Re: Indian Point Unit No. 2  
Docket No. 50-247

SUBJECT: Deletion of 10 CFR 50, Appendix R Exemption for Manhole 21

FIGURE 1

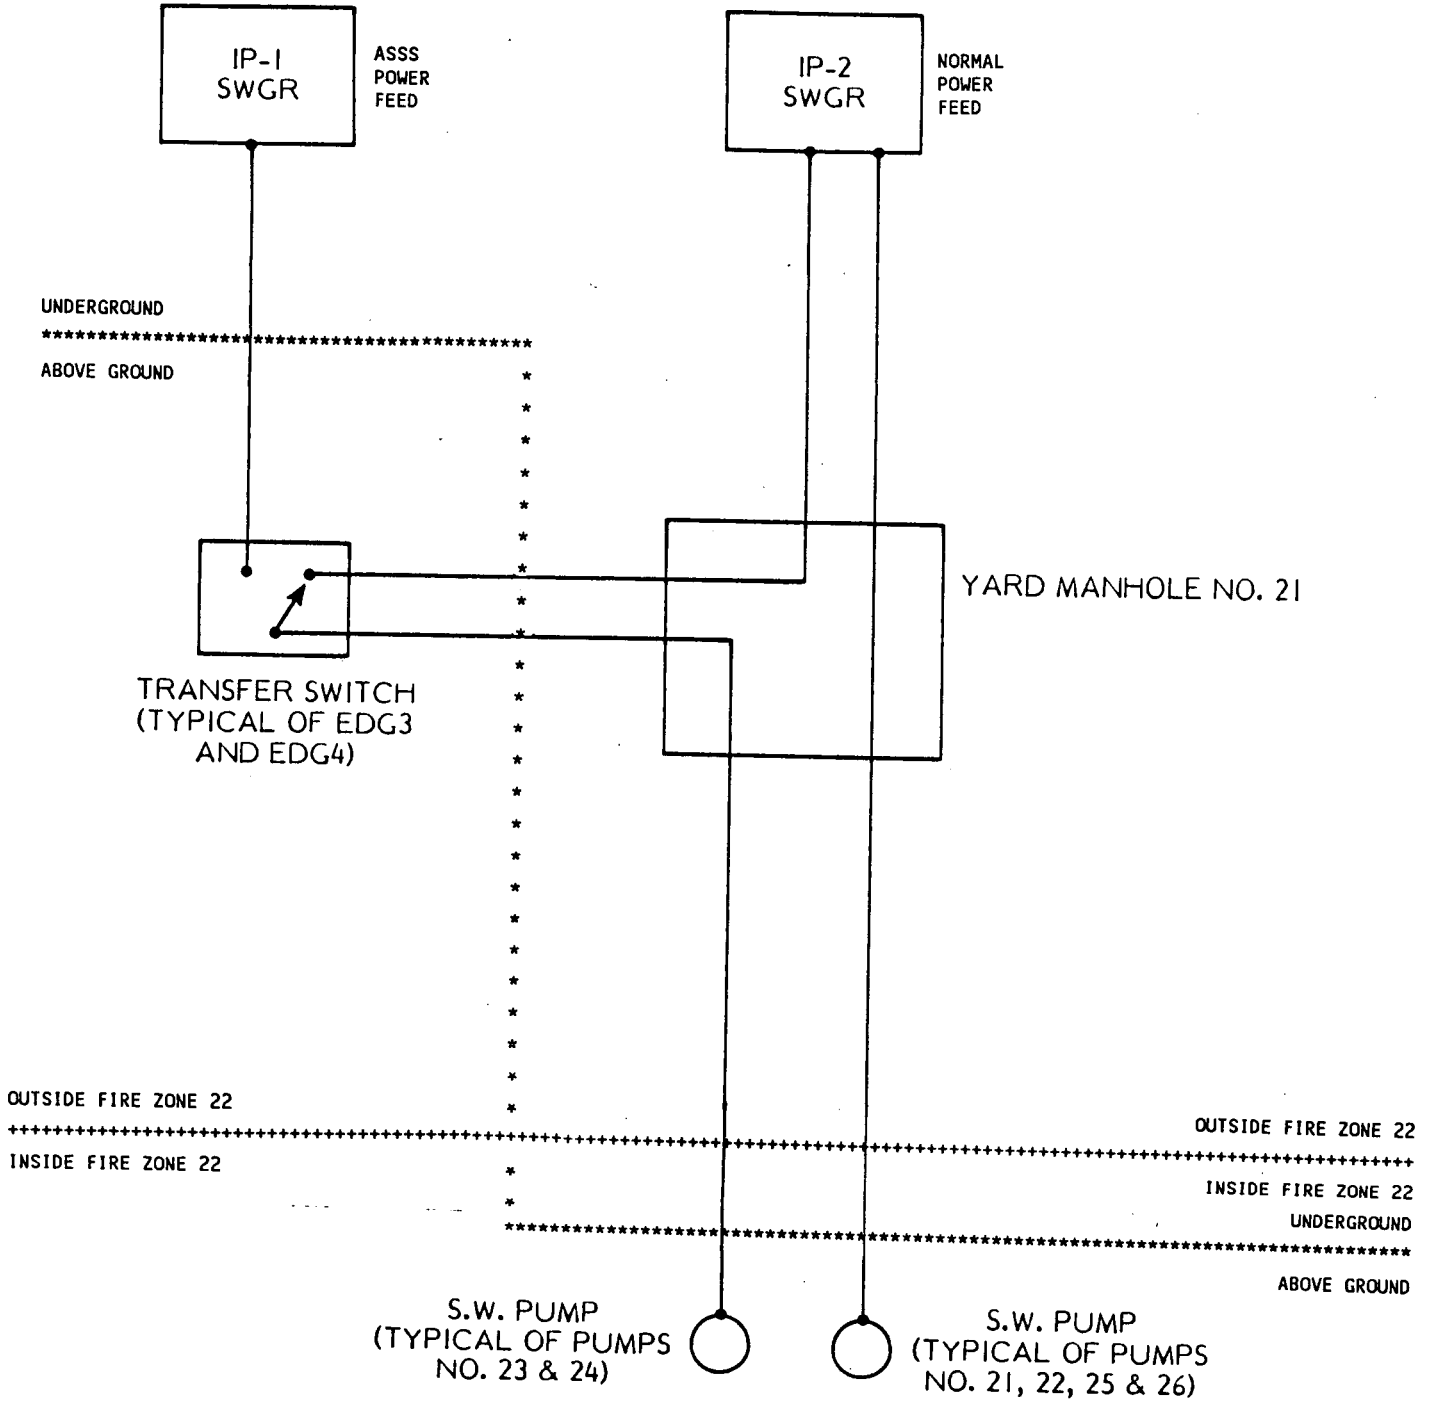
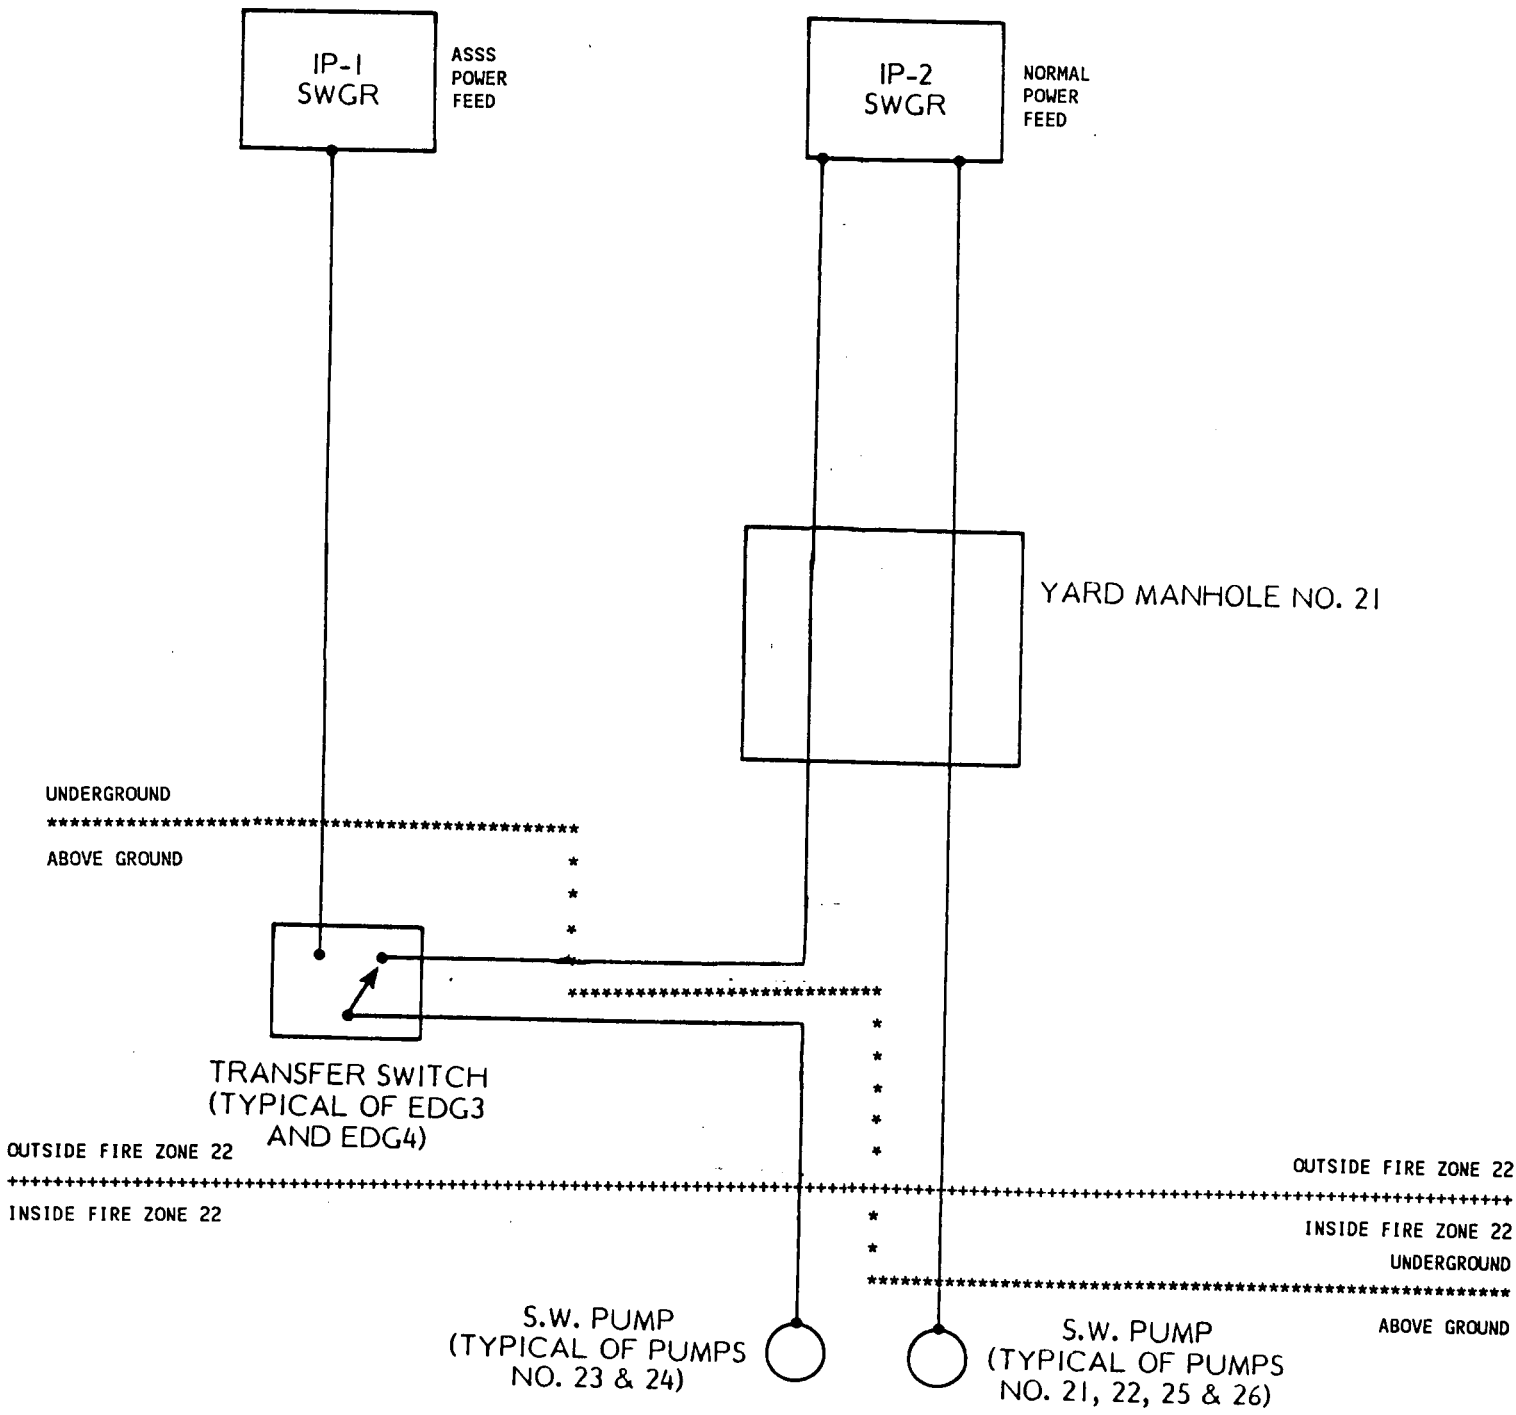
Prior to the 1989 RFO the power feed routing for SWS pumps was configured as shown in Figure 1. Due to this original layout, without the sand, a postulated fire in Manhole 21 could have damaged both the normal and ASSS power feeds which could render all 6 SWS pumps inoperable. The ASSS was designed as a separate train of shutdown equipment subject to compliance with 10 CFR 50, Appendix R, Section III.G.3. Since Appendix R separation was not possible in Manhole 21, an exemption was sought using sand fill in Manhole 21 as a basis. By providing the sand, it would not be possible to support combustion in Manhole 21. In its October 16, 1984 letter, the NRC approved our request and issued Exemption 5. Subsequently, in our February 25, 1988 submittal on cable separation, we also took credit for the sand in Manhole 21 as providing a barrier between adjacent cables.

As discussed at our June 23, 1988 meeting with members of the NRC staff and described in our July 20, 1988 letter, the 1989 RFO modification will have the ASSS power feeds bypass Manhole 21 entirely. The new configuration is shown in Figure 2. In addition, cable separation in Manhole 21 will be maximized by reconfiguring the layout of some of the embedded conduits entering the manhole and rearranging the cables on seismic racks. The new installation will use lead covered cables with the cables for each SWS pump feeder wrapped together with arc proof tape. Since the lead provides a continuous ground path, any potential failures will go to ground and will clear prior to any damage being done to any other feeders. For the postulated locked rotor condition, this

The new configuration will have the power feeds to SWS pumps 23 and 24 exiting the transfer switch boxes and routed above ground in metal conduits. These conduits will remain above ground from transfer switches EDG3 and EDG4 (outside Fire Zone 22) to SWS pumps 23 and 24 (inside Fire Zone 22). Taking into account the Appendix R Exemption for Fire Zone 22 (NRC letter, dated October 16, 1984, Exemption 4) there is no single postulated fire that would render all 6 SWS pumps inoperable.
